Commissioner for Patents
Amendment dated October 10, 2006
Response to Office Action dated April 10, 2006
Page 6 of 10

Serial No.: 10/603,538
Art Unit: 2116
Examiner: Trujillo
Docket RPS9 2003 0022 US1

FIG 2A

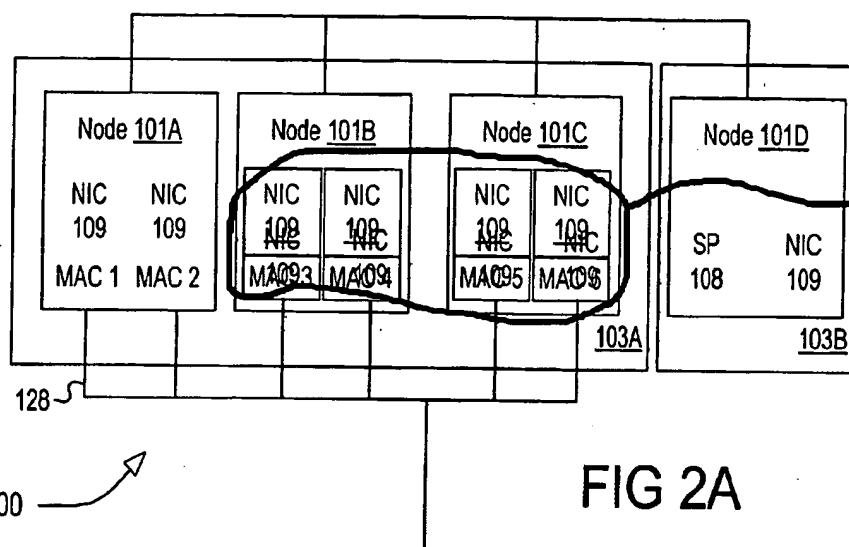
The Office Action objected to FIG 2A as being unclear. Applicant submits herewith a proposed replacement drawing sheet and an annotated sheet showing changes for drawing sheet 2 of 3, which includes FIG 2A. The proposed replacement sheet eliminates unintended text that was included in FIG 2A as originally submitted. Applicants submit that the removal of unintended text does not constitute new matter. Accordingly, Applicant respectfully requests the Examiner to reconsider and withdraw the drawing objection.

Applicant has submitted a proposed replacement sheet for drawing sheet 2 of 3 and an annotated sheet showing changes for sheet 2 of 3. Inadvertent text that was included in the drawing sheet as filed has been removed in the proposed replacement sheet. No other substantive changes were made. Applicant respectfully requests the Examiner to accept the proposed replacement sheet and to withdraw the objection.
